RESPONSE TO REQUEST FOR INFORMATION: 90-102 REGENT STREET, REDFERN (SSD-10382)

This correspondence has been prepared by Urbis on behalf of The Trust Company (Australia) Limited ATF Wee Hur Regent Trust (**Wee Hur**) and relates to the above State Significant Development Application (**SSDA**) at 90-102 Regent Street, Redfern.

It responds to a Request for Information (**RFI**) issued by the Department of Planning, Industry and Environment (**DPIE**) on 17 March 2021. DPIE requested responses to additional submissions by NSW Environment, Energy and Science Group (**EES**), Sydney Metro, City of Sydney and two organisations following their review of the Response to Submissions (**RtS**) report submitted by Wee Hur on 1 March 2021.

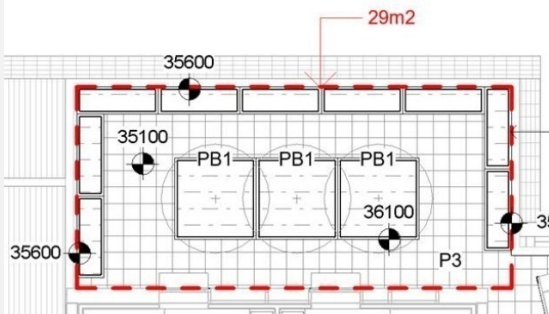
Item	Issues	Action/ Response
		<p>the existing building has significant structural issues which would present significant issues if they were to be retained.</p> <p>Based on the above, it is considered the proposed design is considered entirely acceptable and appropriate.</p>
2	<p>Urban Design</p> <p>Awnings</p> <p>The proposed gaps in the awning and the width of the awning on Marian Street do not provide continuous and adequate weather protection.</p> <p>The architectural plans demonstrate that the breaks in the awning do not correlate with the location of street trees.</p>	<p>The proposed gaps in the awning have been removed in the updated drawing set prepared by AJ+C and submitted with this response.</p> <p>The width of the awning complies with requirements outlined in Figure 13 of the City of Sydney Awnings Policy 2000 which states the awning should be setback from the outer edge of the kerb by no less than 1500mm to accommodate the typical street hole of 1350mm for street tree planting.</p>  <p>Figure 13 Relationship of trees and awnings in typical 3650mm footpaths.</p>
